2. AMENDMENT/MODIFICATION NO. AMENDMENT NO. 0007	3. EFFECTIVE DATE 02/01/08	4. REQUISITION/PURCHASE REQ. NO.	5. PROJECT NO. (If applicable) 06-0050
---	-------------------------------	----------------------------------	---

06-0050, Major Interior/Exterior Repairs, BEQ HP-215

Sketch #1

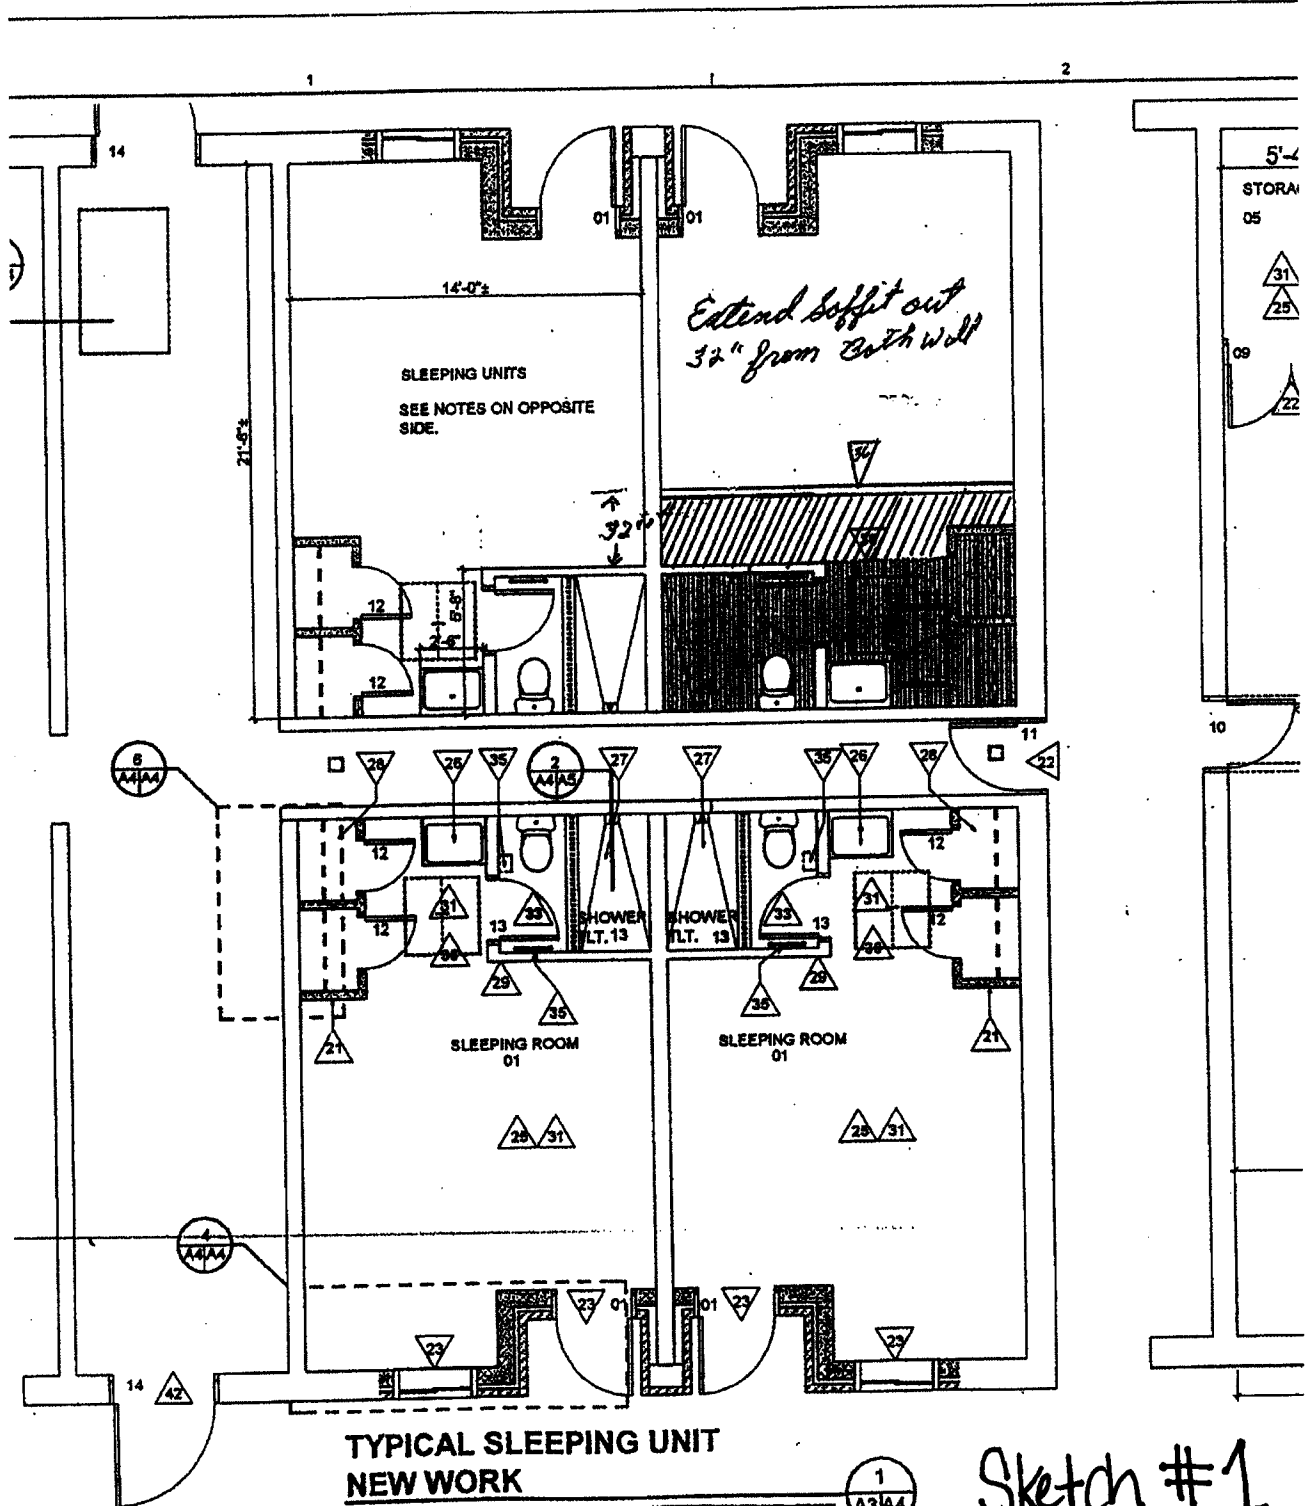
1. The time and date for receipt of proposals is changed to not later than (NLT) 1300, Tuesday, 05 February 2008.
2. Incorporate the attached Sketch #1 into the the project/contract.
3. Extend soffit 32" x 20" out from bathroom wall, as indicated on Sketch #1.
